<b>Subject: Trailer Lighting in Compliance with Federal Motor Vehicle Standard No. 108 and Related Harnesses No Longer Available</b>
--------------------------------------------------------------------------------------------------------------------------------------

*(Also published as Sales Bulletin Letter No. 3512, October 2003)*

**Drawing 1 - Van Trailers**

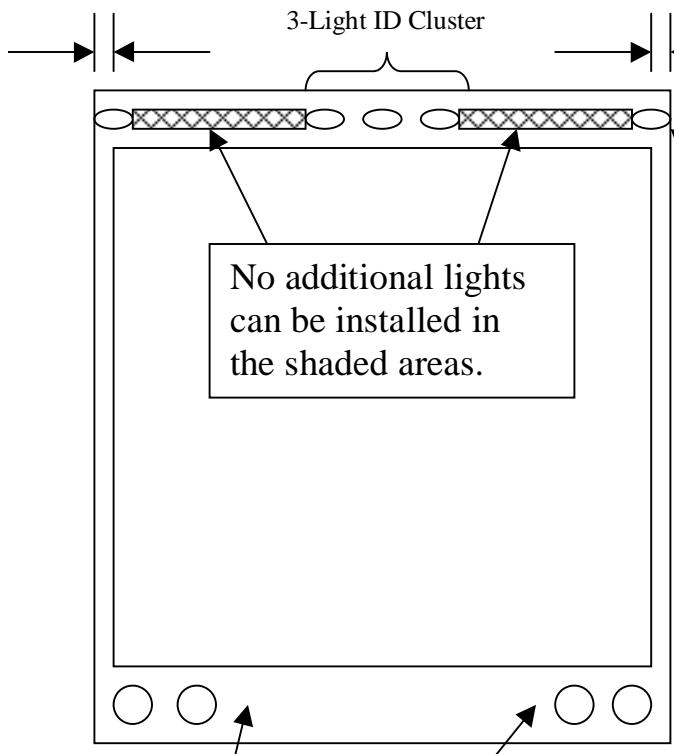
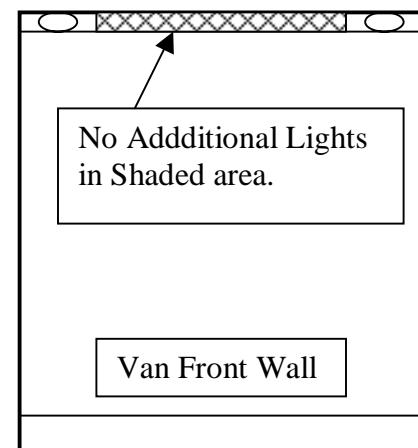
On VAN trailers, we will no longer be able to install more than (5) clearance lights on the rear header. These (5) lights are the 3-light identification cluster and (1) clearance light on each outboard end of the header. (See Drawing 1 for details.) Note that the areas in-between the outboard clearance lights and the I.D. cluster on either side are no longer available for installation of additional lights.

Maximum of 6"  
From Overall Width  
to Center of Light

The outboard Clearance light on Van Trailers is optional and can be eliminated if and only if the outboard Stop/Turn/Tail light is within 6" of the overall width of the vehicle

**Drawing 2 - Flatbed Buckplate**

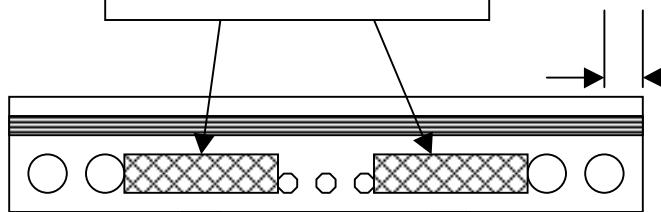
In the case of FLATBED models, the outside stop/turn/tail light on the rear rail is the clearance light that indicates the overall width of the trailer. Adding additional Stop/Turn/Tail lights to the rear of FLATBED trailers is no longer allowed because the D.O.T. has ruled that those additional lights reduce the effectiveness of the 3-light Identification cluster.

6" Maximum from overall width to center of light to act as a clearance light

No additional lights can be installed in the shaded areas.
